# MEMORANDUM

Project No. 200433

March 19, 2021

#### Re: Mercer Island Shell Interim Cleanup Action Plan

Allstructure Engineering Shoring Plan

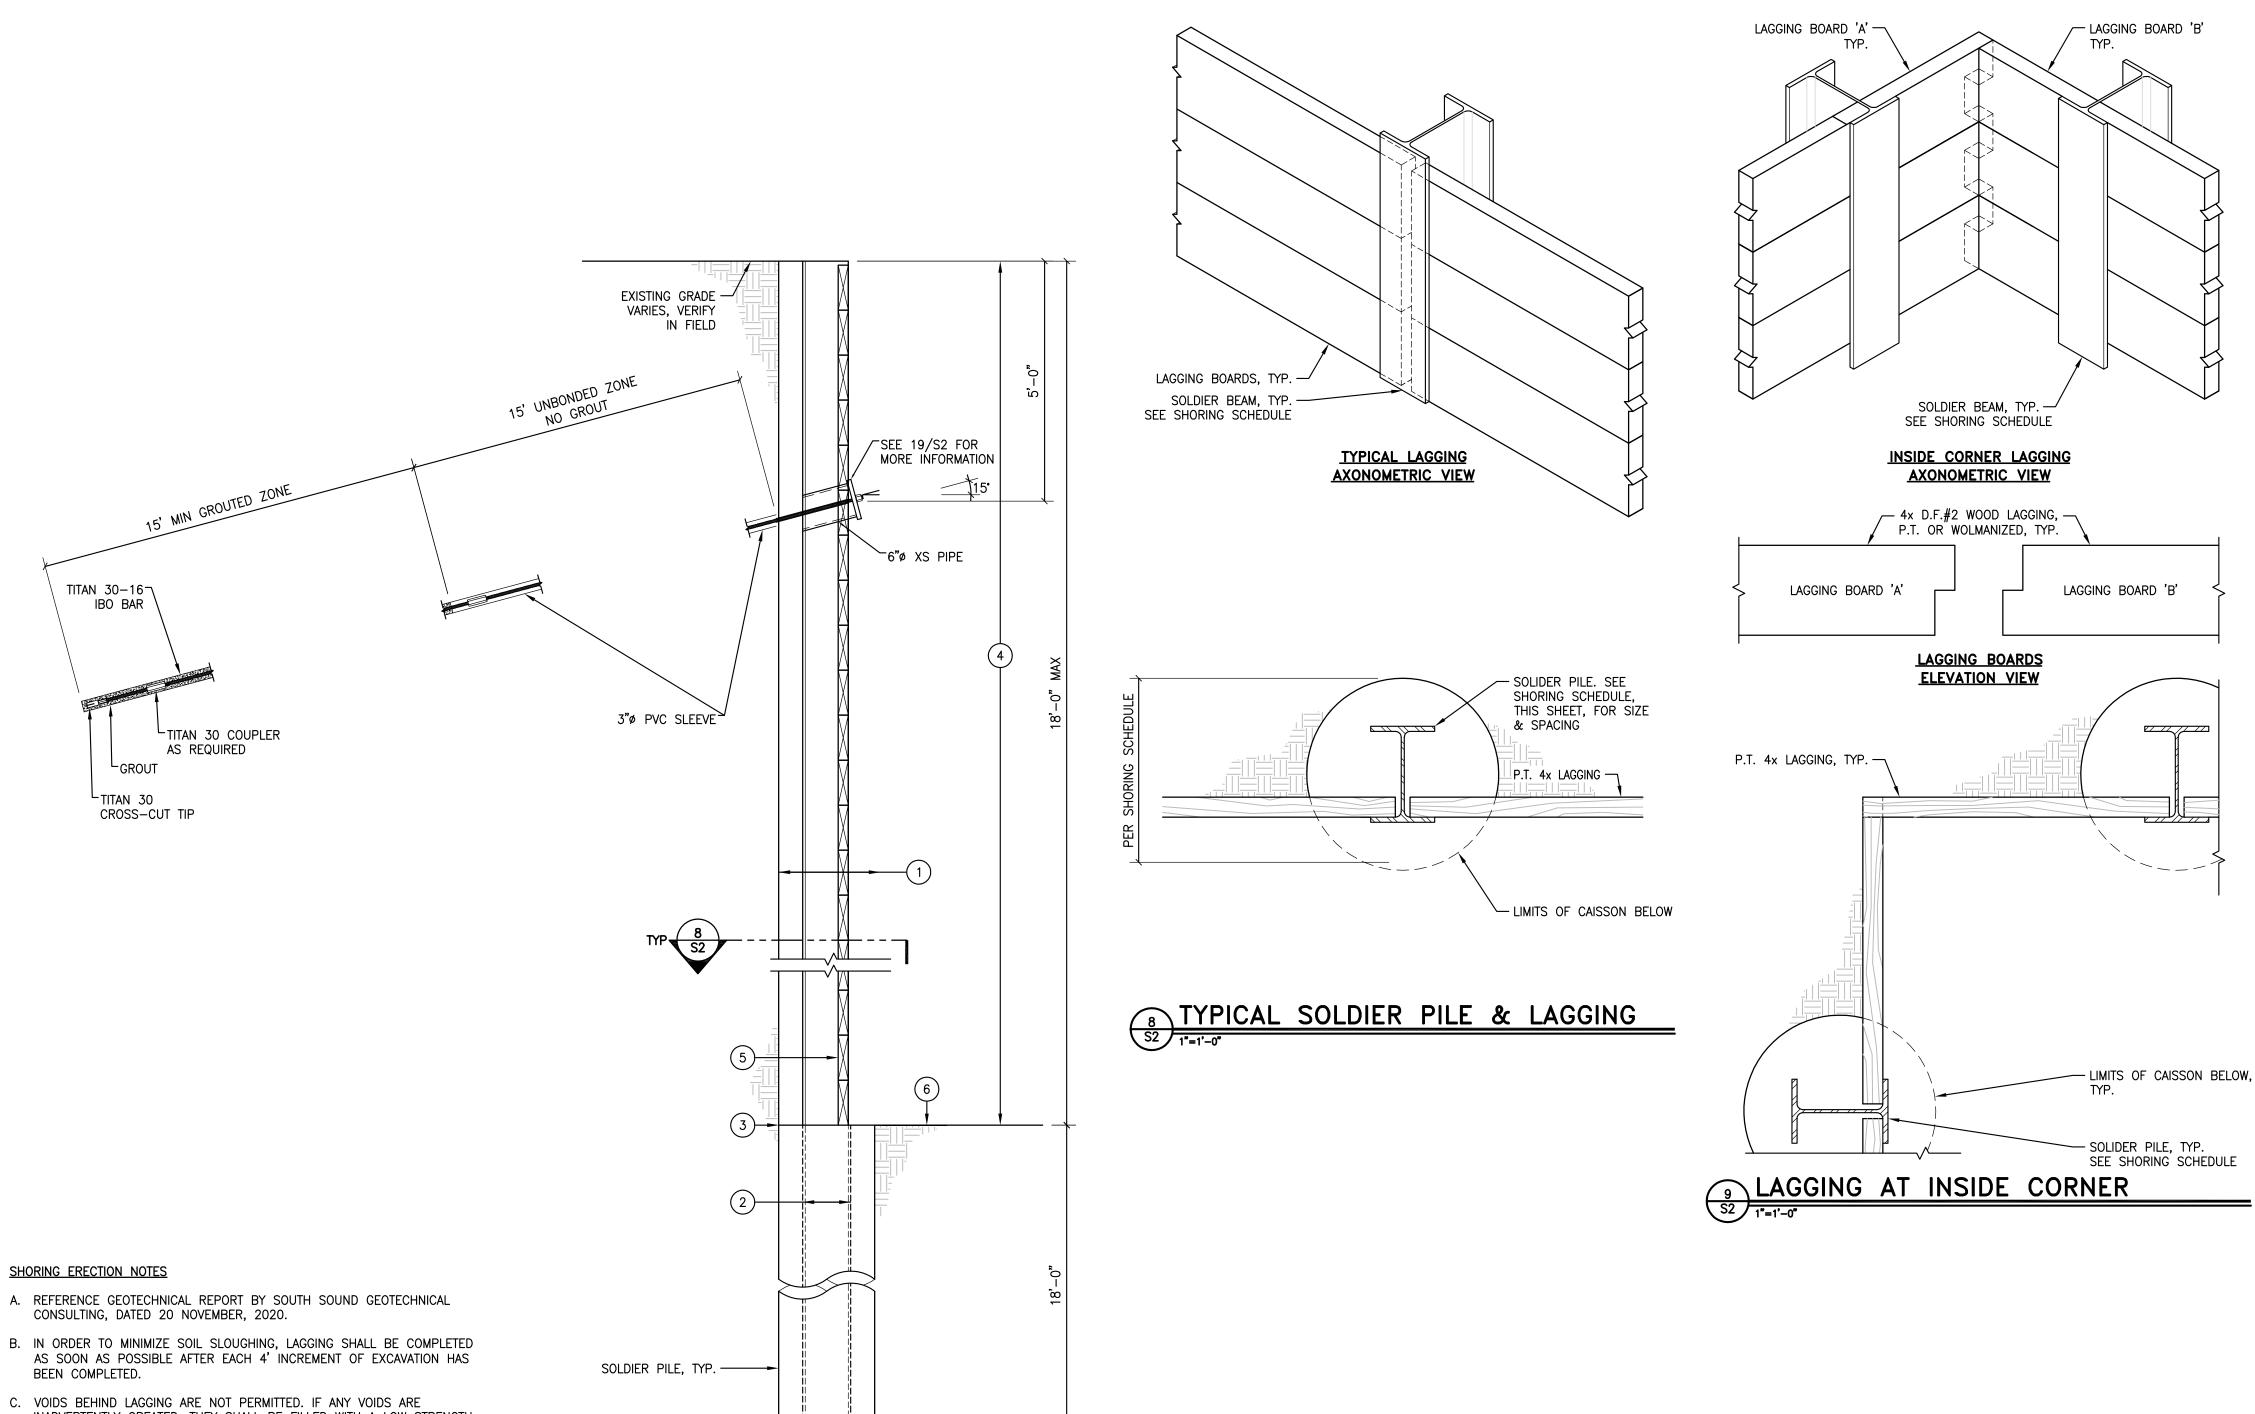
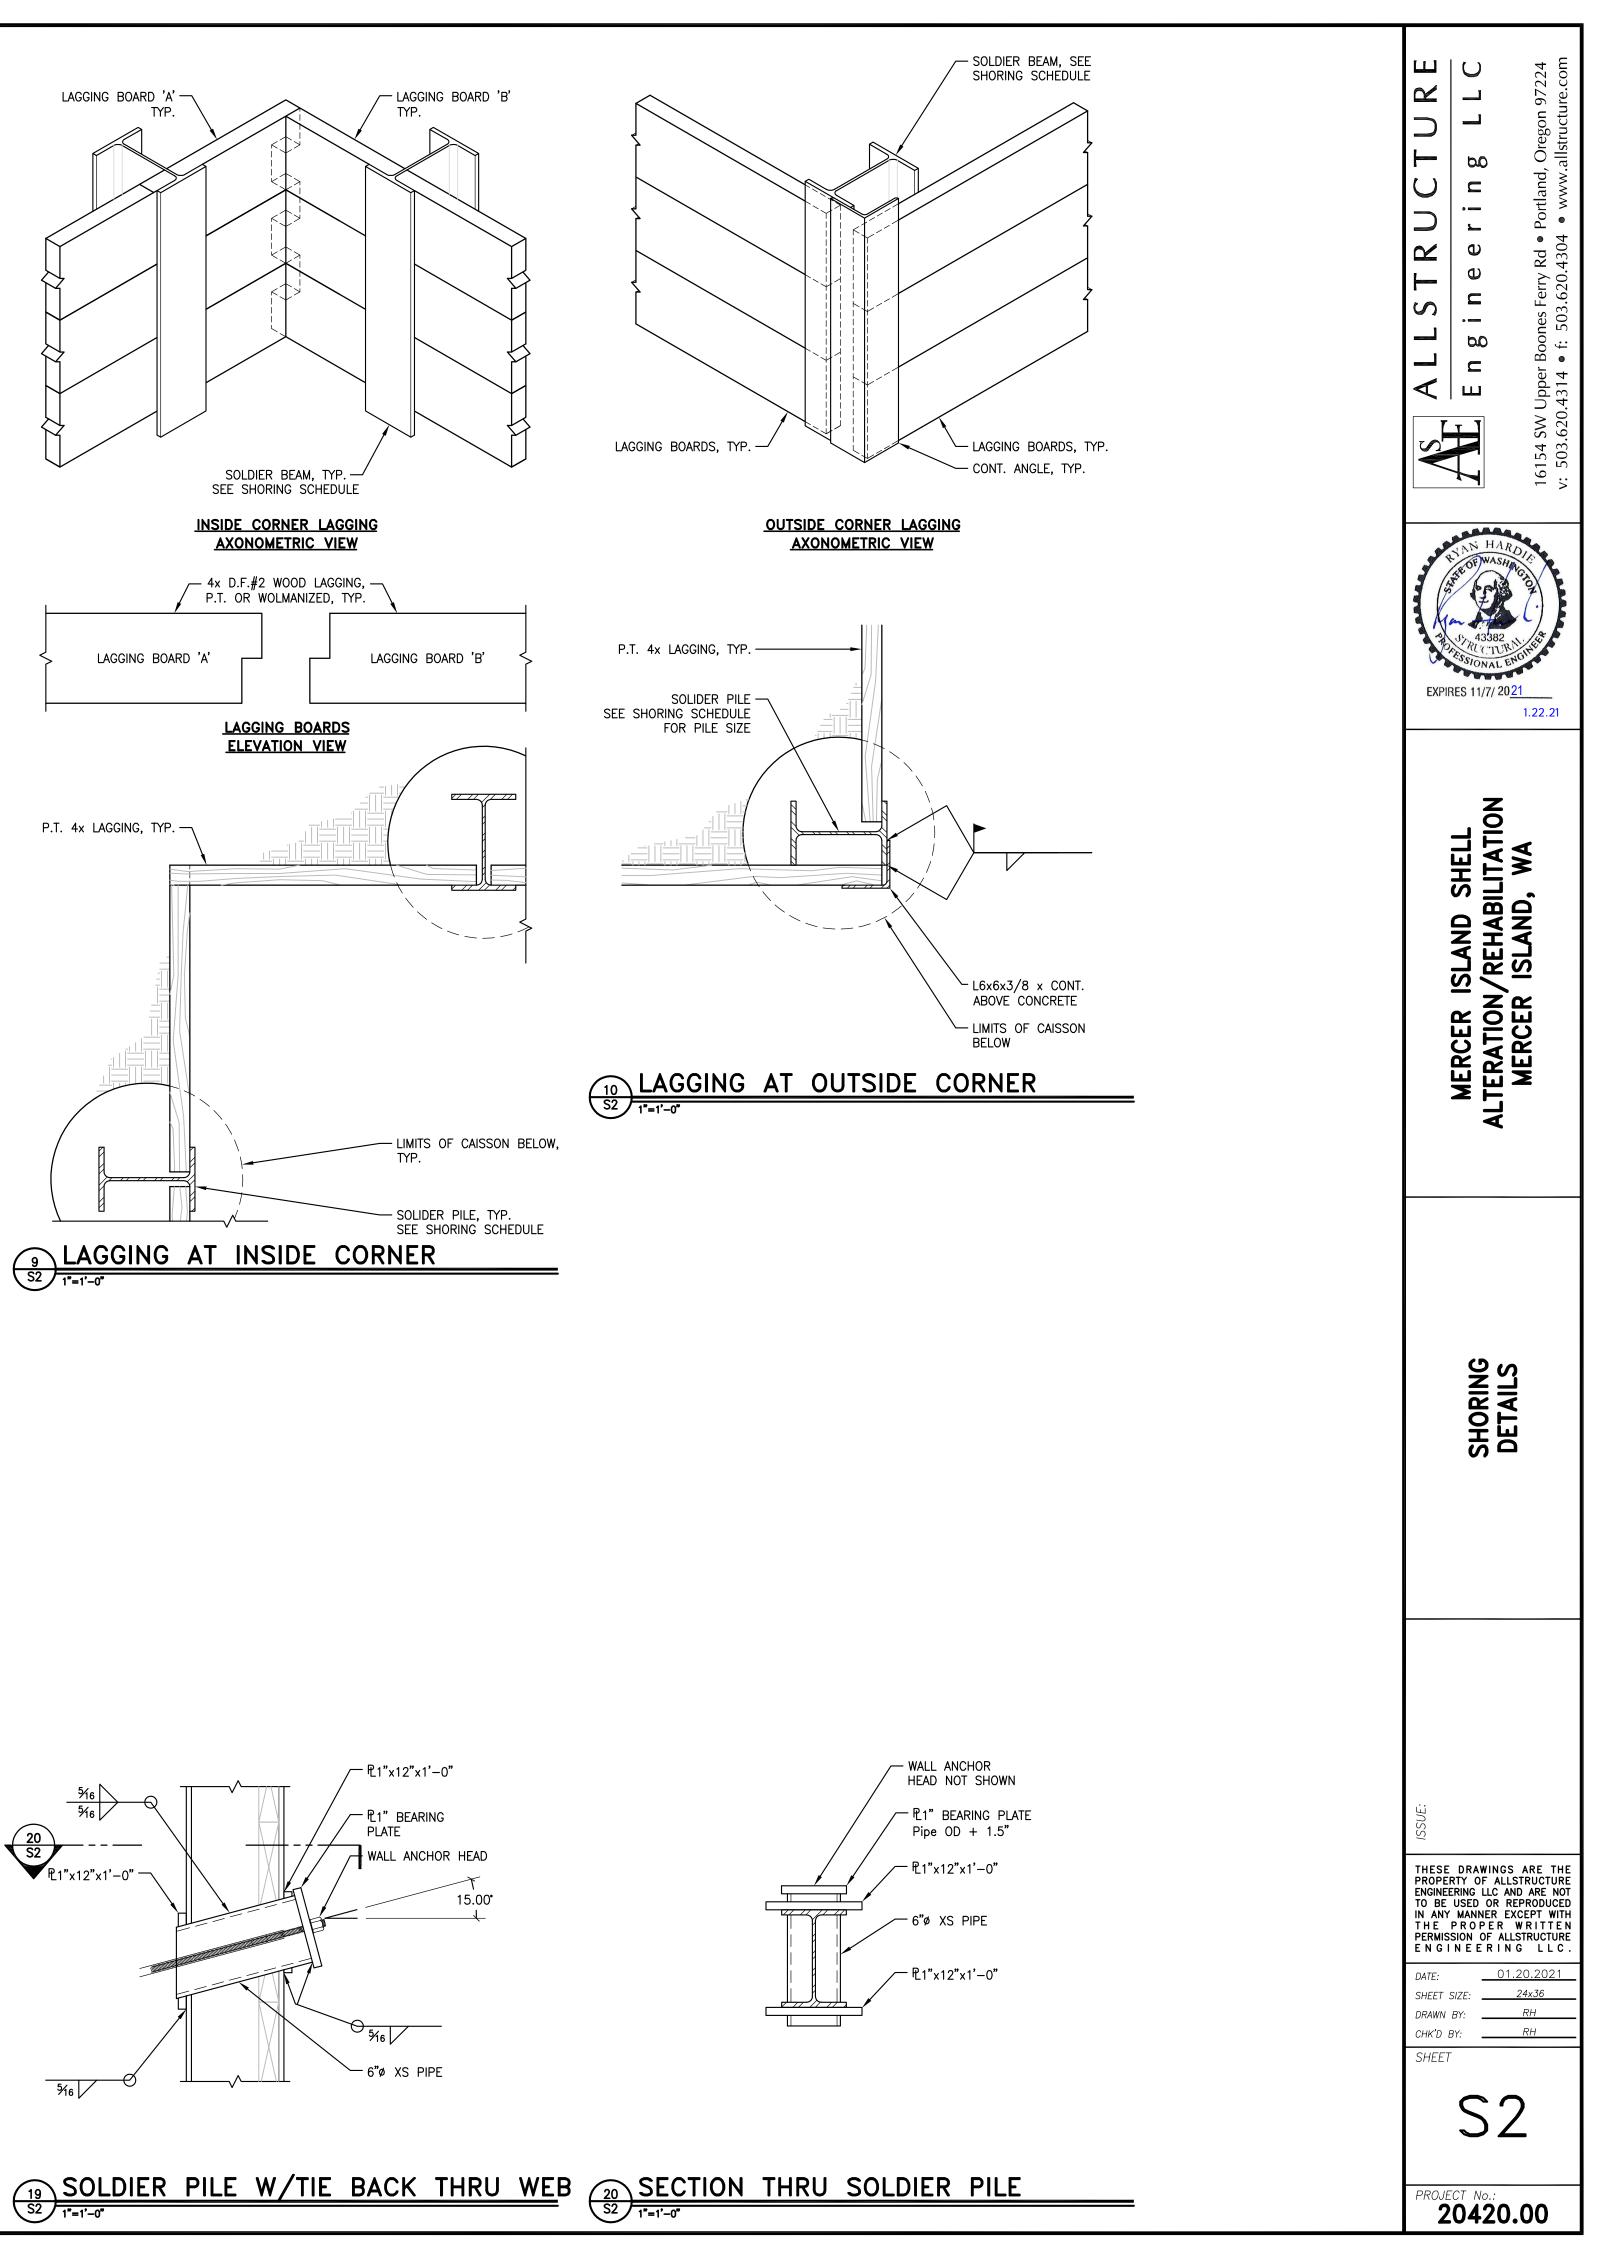
The current shoring plan for construction is provided in Appendix B. To better meet the stated MTCA objectives of the interim cleanup action, it is recommended that the interior shoring alignment be eliminated and the shoring walls along the property lines be extended to the south and west to facilitate sloping of the excavation as necessary up to the south and west property boundary, pending performance soil sampling results.

It is also recommended that the vertical shoring along the north and east property boundaries be designed to facilitate excavation to a minimum depth of 16 feet for purposes of impacted soil removal around the UST basin. A vertical contingency of up to 2 feet is recommended to allow for additional soil removal at depth pending performance soil sampling results. The shoring design should also account for the depth of the planned UST replacement if deeper.

Detailed construction requirements for modifications to the shoring design to meet the interim cleanup action objectives, including permitting and shoring design, should be identified and performed by a structural engineer. The shoring design should also factor in considerations for dewatering of the excavation to achieve design excavation depths as discussed in Section 5.3.
